**ADDENDUM #1**

**PAVEMENT RESURFACING PROJECT-BARTLETT ELEMENTARY SCHOOL**

**BID#FY24014**

**TO***Name:* Plan Holders**PROJECT***Name:* Bartlett City Schools – Pavement Full  
Depth Reclamation*A2H #:* 24218**DETAILS***Addendum #:* 1*Date of Issuance:* 5/16/24*Sent Via:* Email*Total Pages:* 6

<b>D1</b>	INDEX & QUANTITIES
NTS

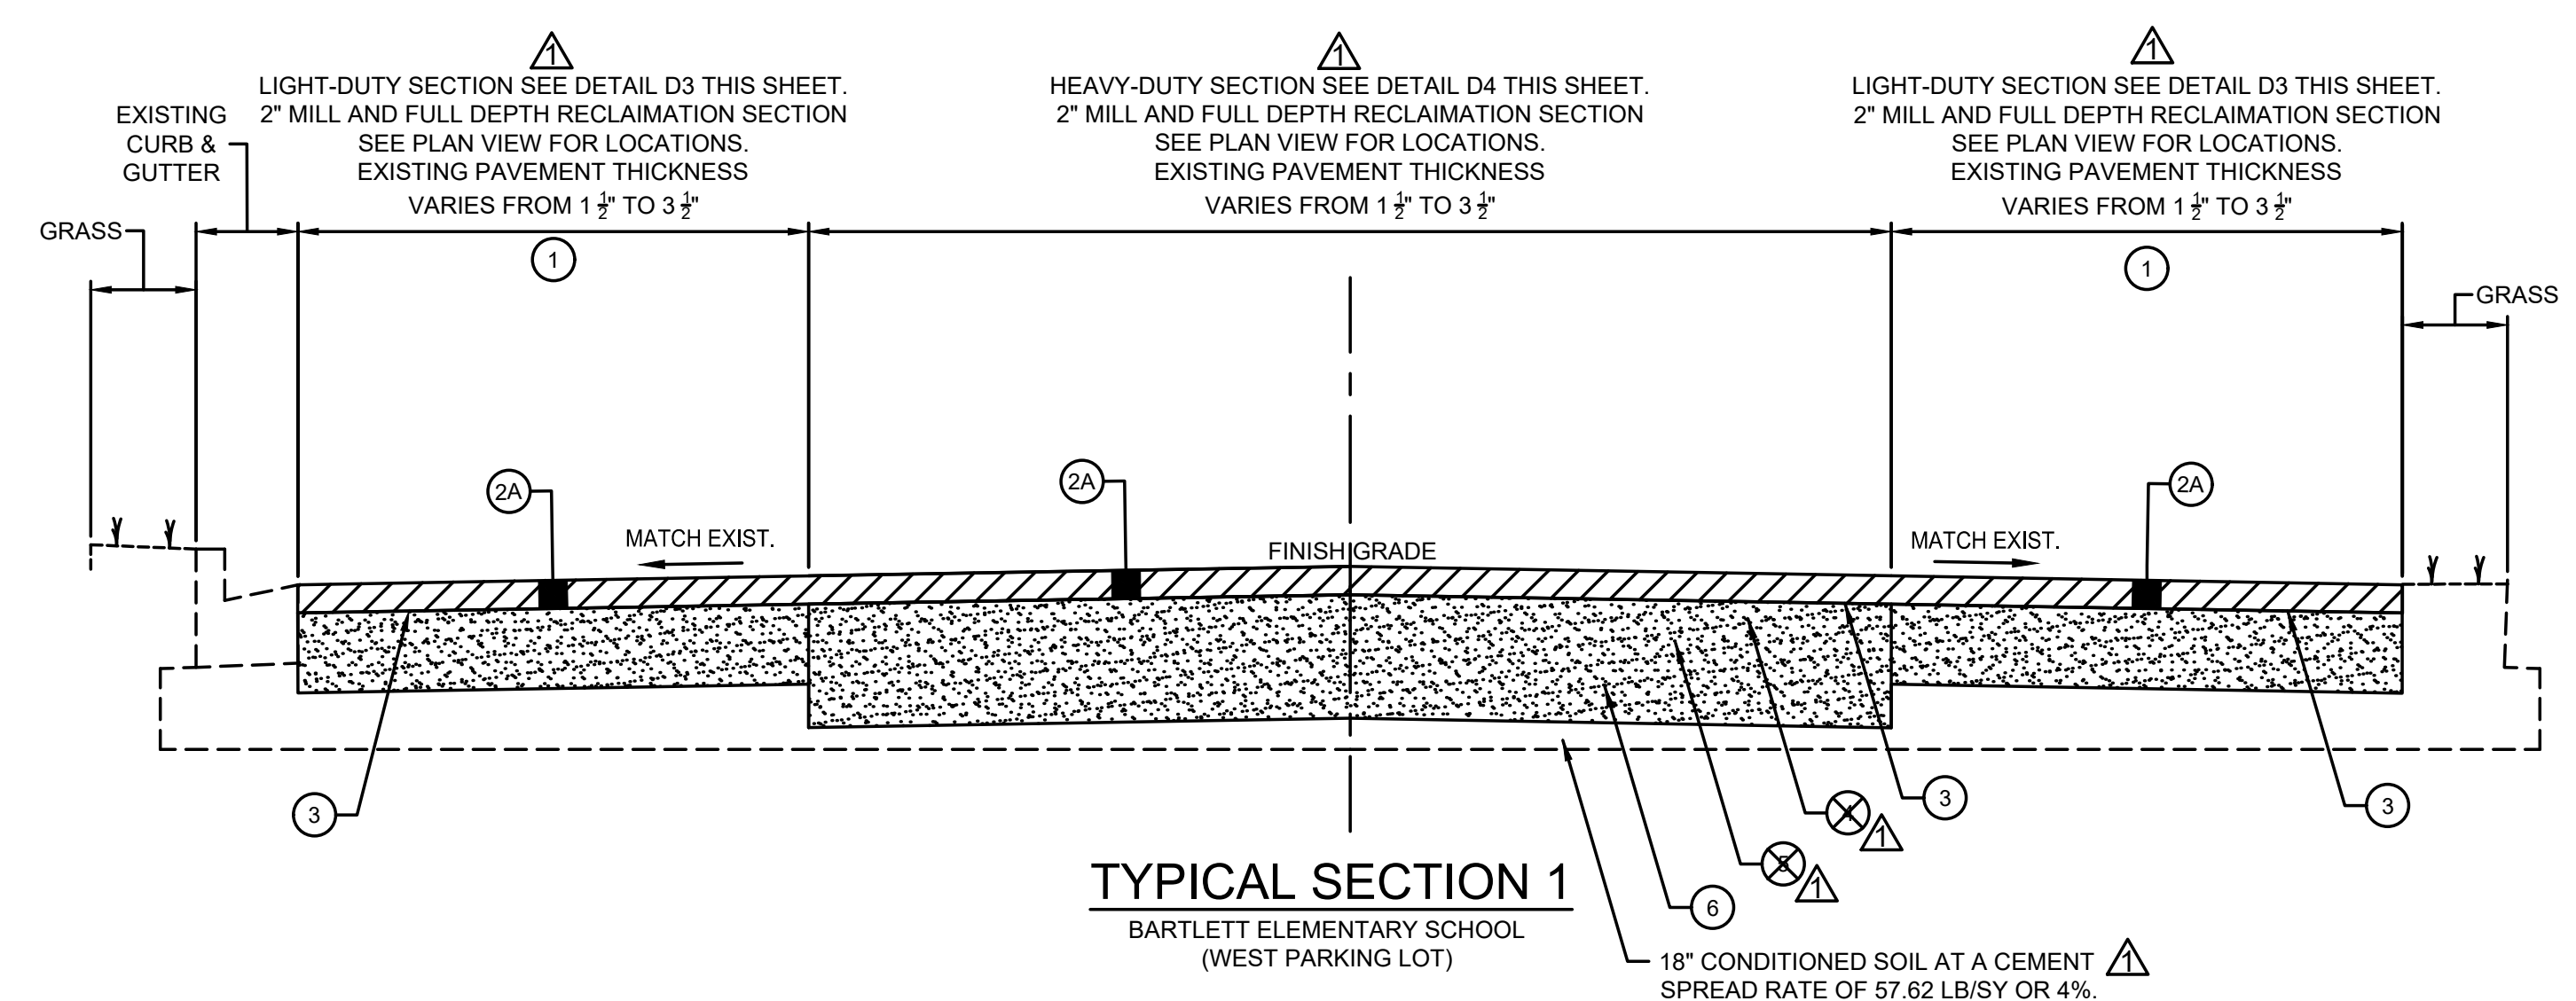
1. Sheet 1A – Index & Quantities: Updated quantities and a note.
2. Sheet 2 – Typical Sections: Updated typical sections, pavement schedule, light & heavy-duty details & added FDR notes.
3. Sheet 5 – Bartlett Elem. Demolition: Updated sawcut lines & mill areas.
4. Sheet 6 – Bartlett Elem. Proposed Layout: Updated the resurface areas and heavy-duty paving area.
